City of Mississauga Department Comments

Date Finalized: 2024-08-08	File(s): A269.24 Ward: 11
To: Committee of Adjustment	
From: Committee of Adjustment Coordinator	Meeting date:2024-08-15 1:00:00 PM

Property Address: 6150 Duford Drive

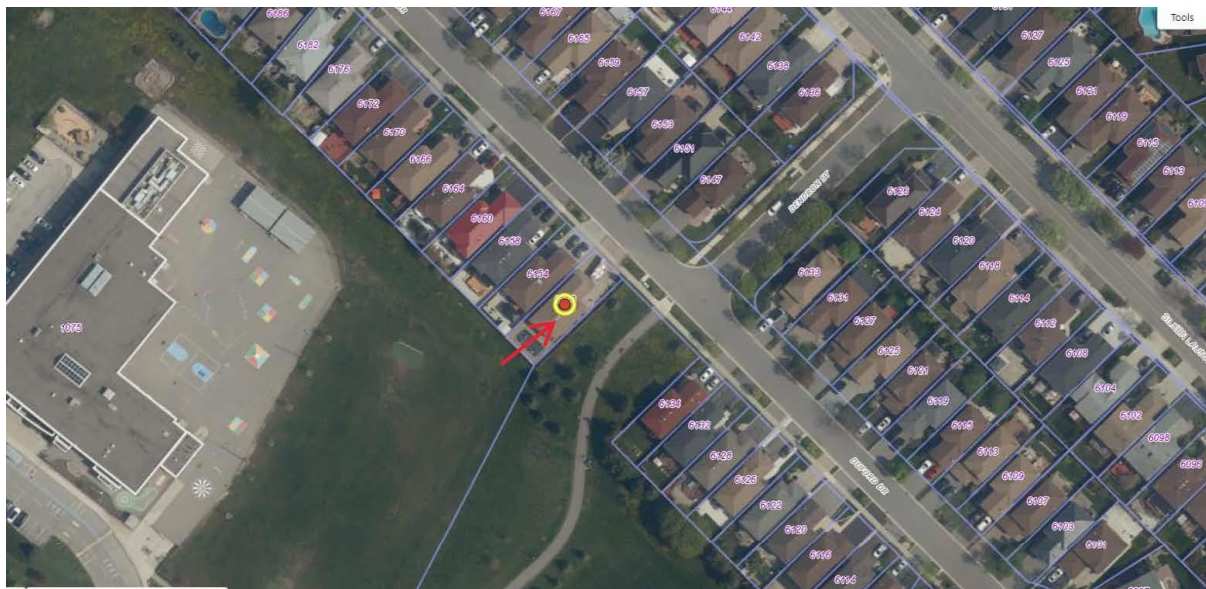
The subject property is located in the East Credit Neighbourhood Character Area and is designated Residential Low Density II. Section 9 of the Mississauga Official Plan (MOP) promotes development (including its features such as driveways and landscaping) with appropriate urban form and site design, regulating that such development is compatible with the existing conditions, the surrounding context and the landscape of the character area. The planned character of the area are dwellings accessed by appropriately sized driveways. The existing driveway is not compatible with the existing or planned character of the area. Staff are

of the opinion that the general intent and purpose of the official plan is not maintained in this instance.

The proposed variance relates to a widened driveway on the subject property. The planned character of the area are dwellings serviced by appropriately sized driveways that can accommodate the parking of vehicles required by the zoning by-law for each property. The intent of the driveway width regulations in the by-law is to allow a driveway to accommodate two vehicles parked side by side, with the remainder of the front yard being soft landscaped area. While the existing driveway would be able to facilitate the parking of 3 or more motor vehicles across, the existing driveway also eliminates a large portion of the soft landscaping required by the zoning by-law in the front yard. Further, the existing driveway creates a significant amount of hardscaping that dominates the perceived street frontage of the property. The subject property does not possess the frontage necessary to support the size of the driveway and remain within the intent of the regulations.

While staff are not in a position to interpret the zoning by-law, staff note properties zoned R5 require a minimum landscaped soft area of 30% in the yard containing the driveway. In reviewing the drawings submitted, the front yard does not appear to meet the minimum landscaped soft area requirement. Furthermore, it appears a large portion of the rear yard encompasses hardscaping interlock material. Staff note the drawing depicts soft landscaping along the side and rear lot lines in the rear yard, however there is no dimension provided on the site plan. Staff note further variances may be required concerning setbacks from the hardscaping material in the rear yard. Staff are of the opinion that the application be deferred to allow the applicant the opportunity to redesign the driveway and identify the correct variances.

The City recommends the application be deferred for redesign and to identify the correct variances.
